BUELL
BYTES

COMPUTER GENERATED
TECHNICAL UPDATES & INFORMATION
FOR BUELL MOTORCYCLES

ISSUE #2

SEPTEMBER 1995

Ignition Timing- 1996 Models

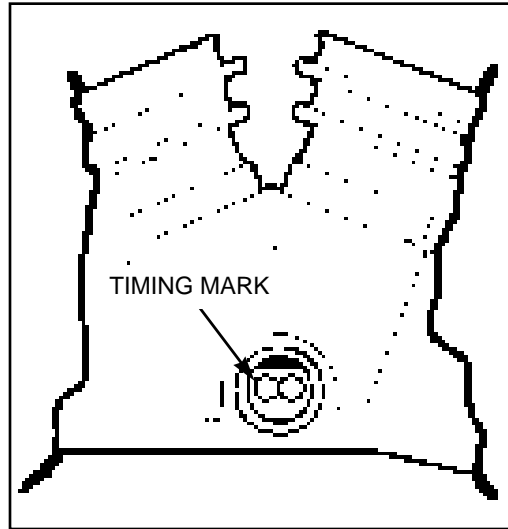
All 1996 Buell motorcycles should have the ignition timing checked with the vehicle **AT IDLE** (950-1050 rpm) **not** at 1650-1950 rpm as with earlier models. The timing mark that should be visible will be a “lazy 8” or a pair of side-by-side drilled dots.

Incorrect ignition timing could result in a loss of performance or even severe engine damage. Ignition timing procedures are outlined in the 1996 Buell Predelivery & Setup Manual and the 1995-1996 Buell Service Manual.

Front Fender Change

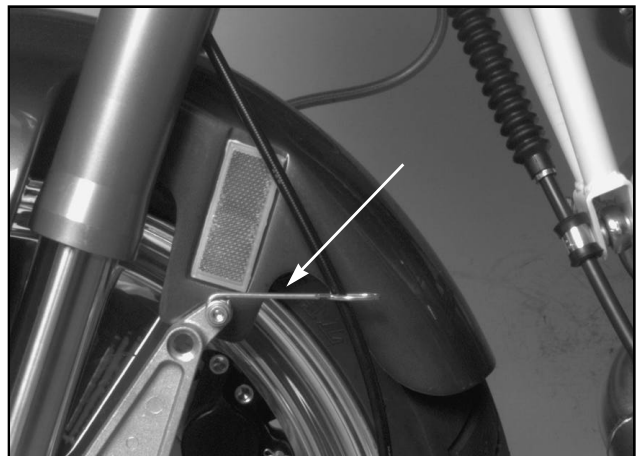
Beginning with VIN: 49 state: **1337**, Calif.: **052** the front fender has been changed to eliminate the two plastic clips used to retain the speedometer cable. A wire form, attached to the front fork, now serves this purpose. Replacement fenders will not have the holes for the old style clips so you must update.

The part numbers to do this are:

Screw	67369-95Y
Washer	67370-95Y
Wire form	67368-95Y

D-Washer Change

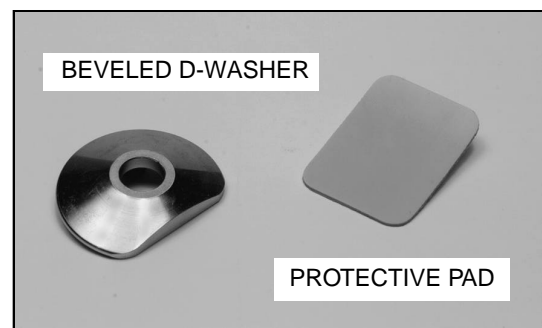
Beginning with vehicle VIN: 49 state: **1242**, the top engine mount D-washer is now beveled to prevent contact with the steering neck tube.

Protective pads, p.n. 16768-96Y (white for S2) or p.n. 16767-96Y (gray for S2-T) are available for vehicles with earlier style washers. This pad is installed on the back of the neck tube to prevent contact with the painted surface.
